Access Compliance Report

Public Rights-of-Way

| Intersection ID: 29162 | Main Street: FIRESTREAK_DR | Cross Street: ADVOCATOR_LN | Location: NW |
| ADA ID: 16F3C0217447 | Ramp Type: Perp | Initial Pass/Fail: Fail | Overall Compliance: No |

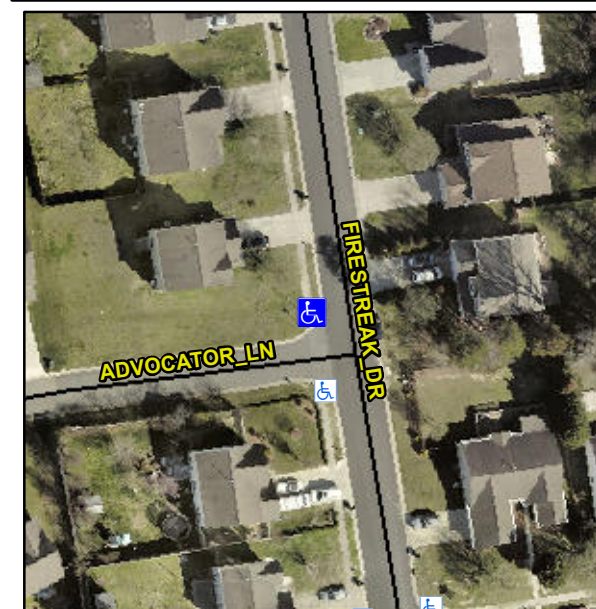
R304.5.1

| Compliance | Description | Data | Compliance | Description | Data |
|------------|-----------------------|------|------------|-----------------------------|------|
| No | Ramp Width (in) | 40.0 | Yes | Ramp XSlope (%) | 0.9 |

Remove & Replace Entire Ramp.
